## DFCM Addendum #1

**Reference:** Zions Building Kitchen Update  
Utah State Fairpark  
DFCM Project #25266370  
U3P Event #DA25040

# ADDENDUM NO. 1

## FAIRPARK ZION'S KITCHEN

EP100

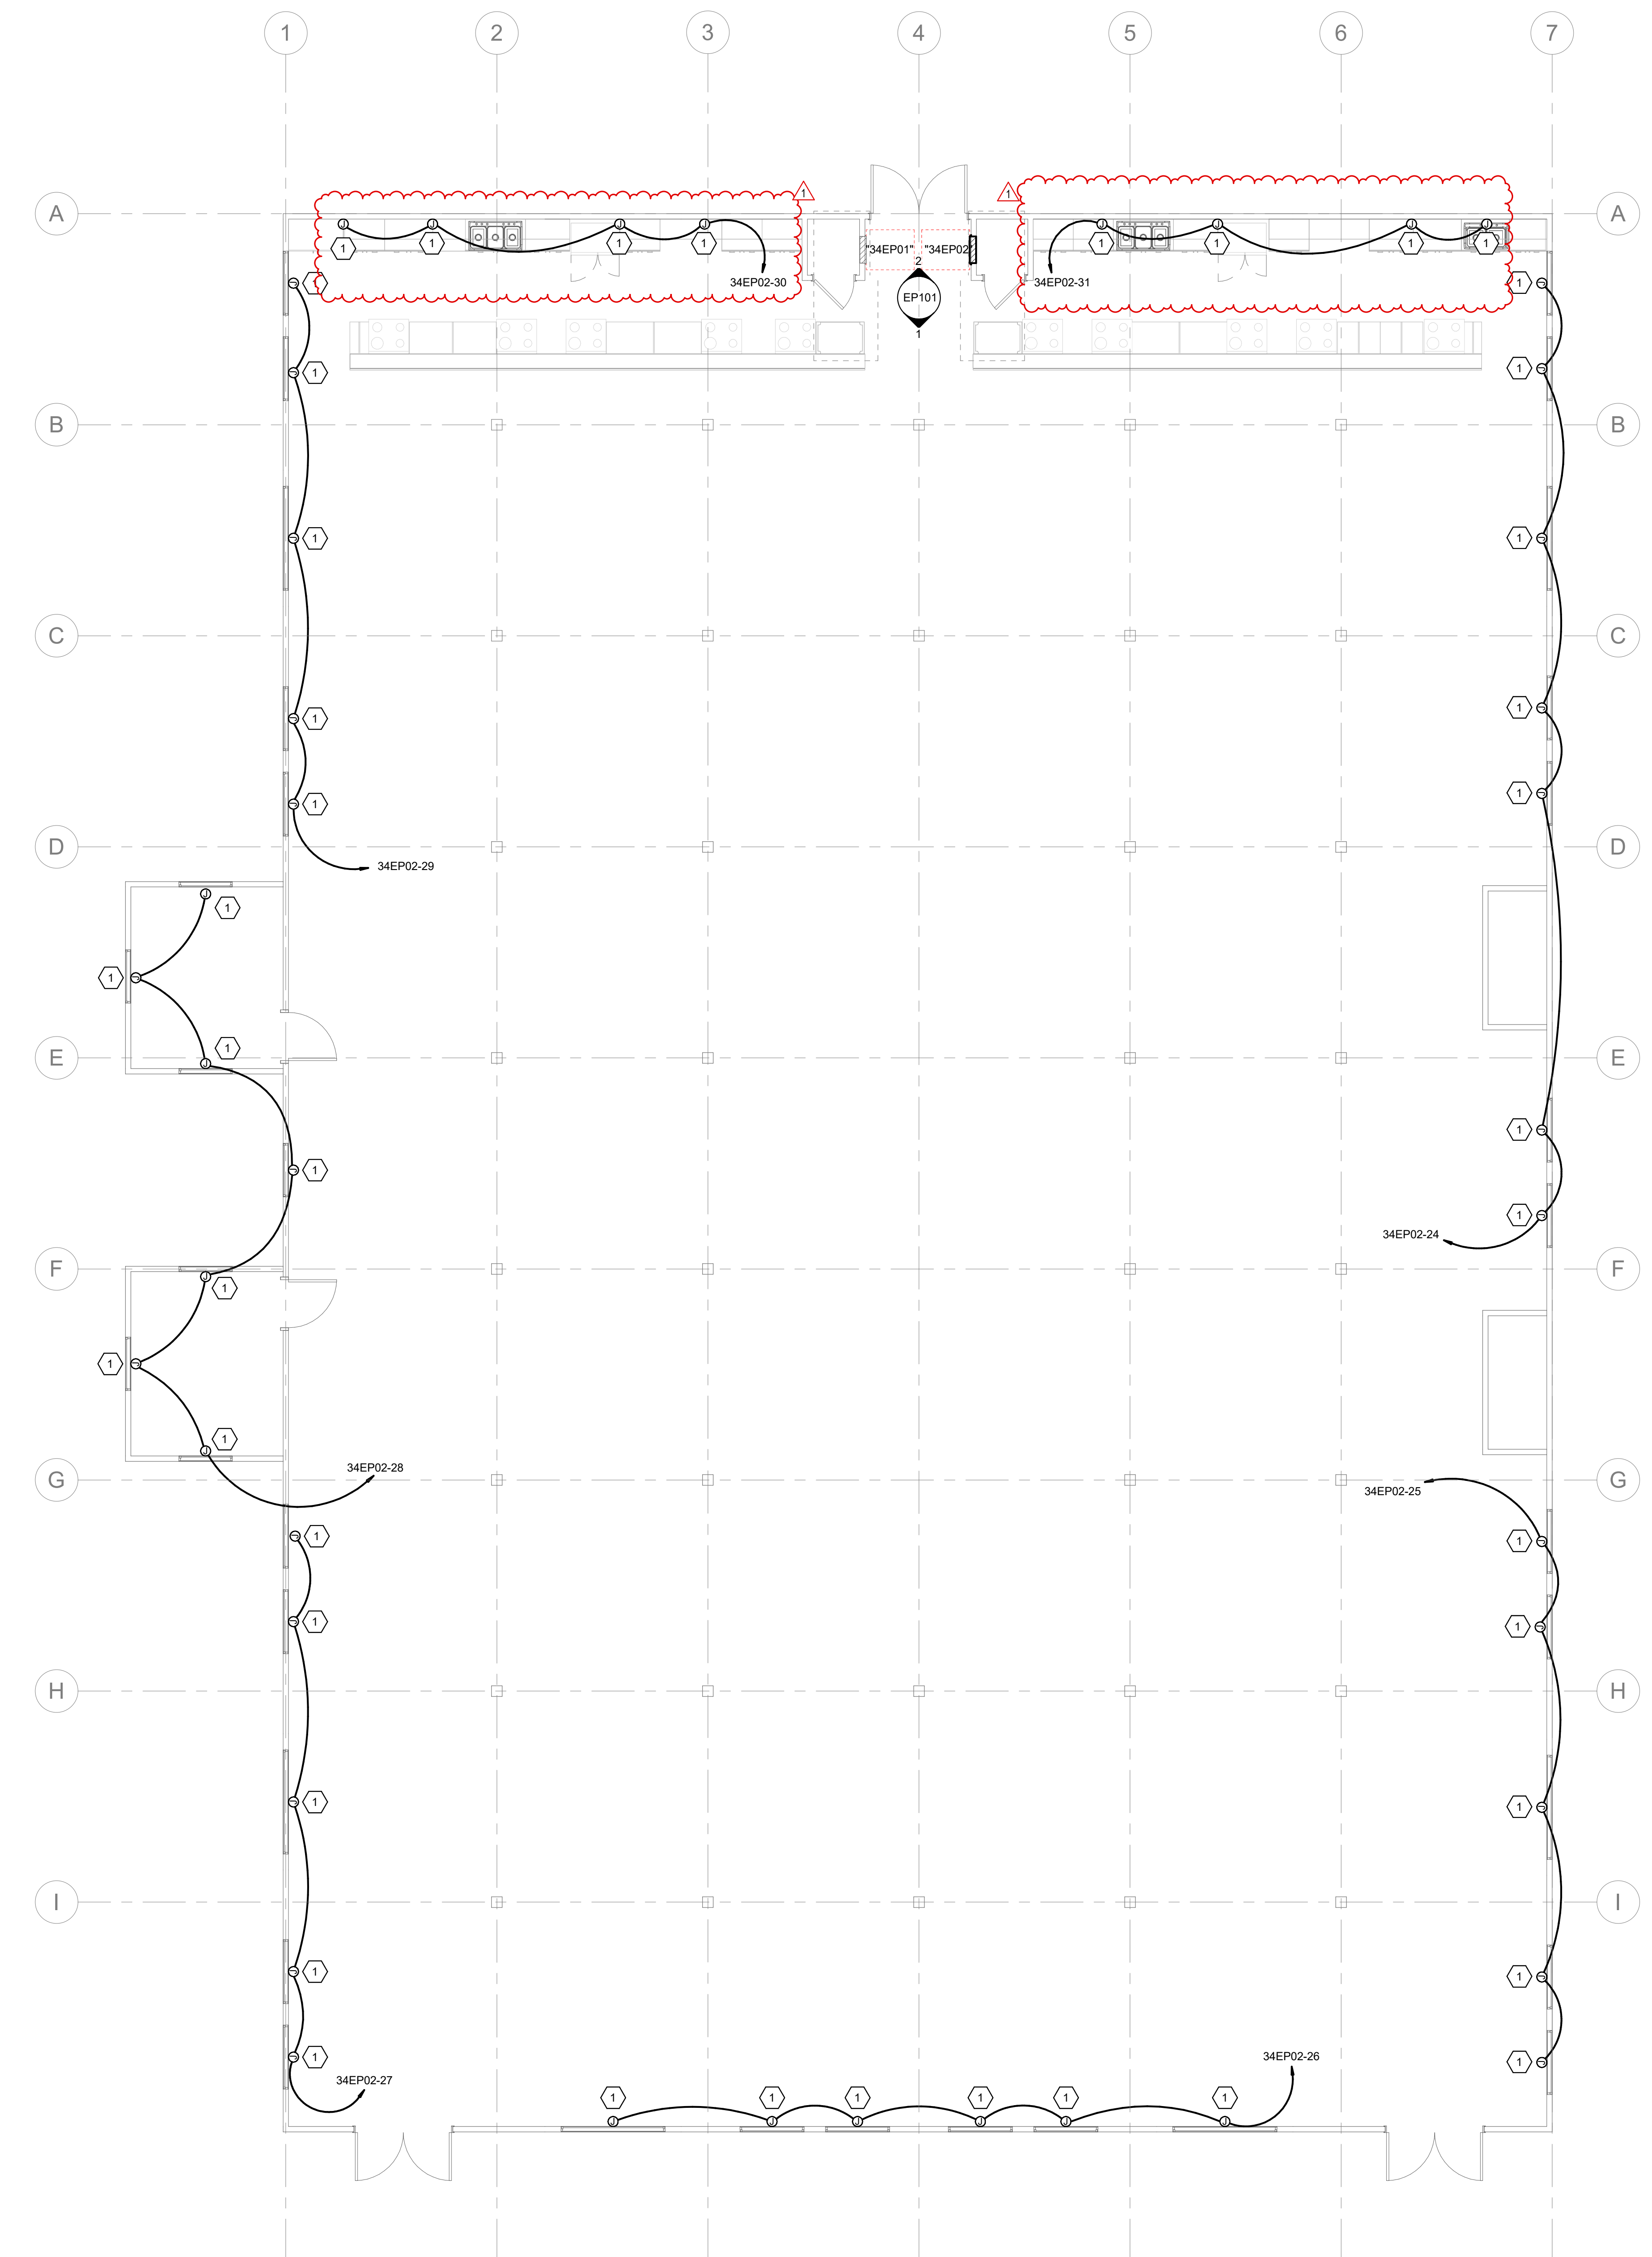
1. **EP100** – Added Electrical motor shade controls to the north windows.
2. **EP101** – Added electrical motorized shade controls to elevation view. Added keynote 2.
3. **EP601** – Updated Electrical fixture schedule. Updated panel schedule '34EP02'to include new circuits.

- PROVIDE ALL ELECTRICAL CONNECTIONS TO MOTORIZED SHADES. PROVIDE ALL ROUGH-IN, CABLING, AND TERMINATIONS FOR ALL CONTROLS PER MANUFACTURERS SPECIFICATIONS.
